DRAFT LAKE TANEYCOMO TMDL
PUBLIC COMMENTS

Public Notice
July 30 – Sept. 13, 2010

Lake Taneycomo
WBID # 7314

Taney County, Mo.

Source: MDNR, 2009 – Lake Taneycomo 2010 303(d) Assessment Worksheet

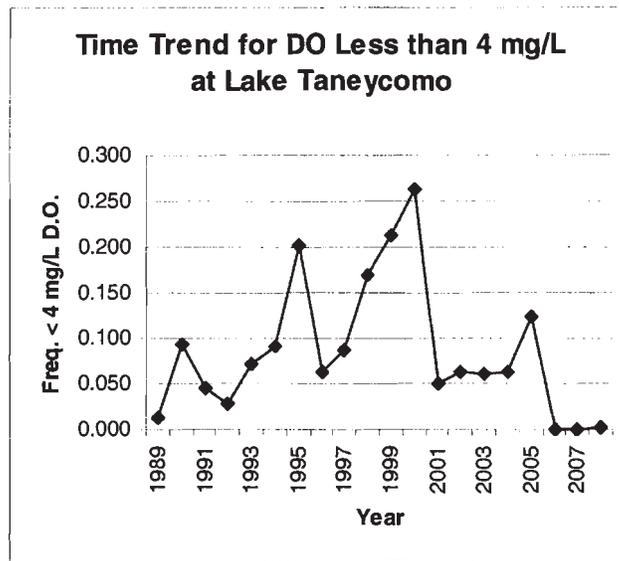
Comment #3 – *Section 11. Summary and Introduction to Future Implementation of this TMDL, last paragraph states: "Rather than continuing to put funds into additional studies, it is recommended those funds be put toward implementing already-identified solutions." In addition, Section 12. Implementation: Future Recommendations, in first paragraph it states "However, a combination of structural and operational actions (as detailed in Section 10), with due regard for water supply demands, are needed to ensure that Table Rock Dam's discharge more consistently reaches DO levels of 6 mg/L during the low DO season." The report recognizes that 6 mg/l 100% of the time is likely not possible, and as such, consideration of changing the designated use and/or state water standard may be necessary to reflect the reasonable and prudent DO conditions in the tailwater.*

The draft Lake Taneycomo TMDL describes in detail that achieving the 6 mg/L minimum dissolved oxygen criterion is technically feasible using currently identified technology and operational practices. While some options or methods may be impractical when implemented in isolation (e.g., penstock injection), a coordinated approach that uses multiple methods of adding dissolved oxygen to Table Rock Dam's discharge (e.g., forebay diffusion, turbine venting, and load spreading) can allow Lake Taneycomo to achieve applicable water quality standards.

The state Listing Methodology document assesses compliance with the dissolved oxygen standard based upon the percent of all criterion measurements taken at the College of the Ozarks monitoring site. If more than 30 measurements are made, the water body is judged to be impaired if more than 10 percent of samples exceed the standard. The dissolved oxygen standard for the Lake Taneycomo cold-water fishery is 6 mg/L. Six of the last eight individual years, and the eight year average for the frequency of exceedance, are greater than 10 percent. At Branson, on the lower portion of Lake Taneycomo, the exceedance rate is only about five percent (gathered through bimonthly sampling).

Since 1998, the daily minimum dissolved oxygen has failed to meet the state dissolved oxygen standard 31.7 percent of the time. Over the last seven years, the exceedance rate is somewhat better, 26.8 percent. Since 2006, operations at Table Rock Dam have been much more effective in keeping minimum dissolved oxygen levels above 4 mg/L. Dissolved oxygen frequency of exceedance and time trend plots have been included below for your reference. These plots illustrate that, while applicable water quality standards are not currently being met, conditions in Lake Taneycomo are improving as SWL and Southwestern Power Administration implement technologies and practices to improve dissolved oxygen in Table Rock Dam's tailwater.

Because dissolved oxygen conditions and the cold-water fishery use are being met much of the year (especially outside the low DO season), it is premature to discuss changes to the designated uses and/or water quality standards for Lake Taneycomo. Especially considering water quality conditions have improved during the low dissolved oxygen season over time due to structural and operational modifications at the dam. TMDLs are developed to address applicable water quality standards as found in existing state and federal rule. Therefore, modification of the cold-water fishery designated use and applicable criterion will not be included in the TMDL as a regulatory option. However, should SWL wish to discuss this topic further, the Department would be willing to review any relevant data and information during a future triennial review of Missouri's Water Quality Standards. Any information used to support a redesignation of beneficial uses would need to demonstrate that a lower aquatic life protection use or DO criterion would not have negative effects (i.e., impair) the existing cold-water fishery designated use.
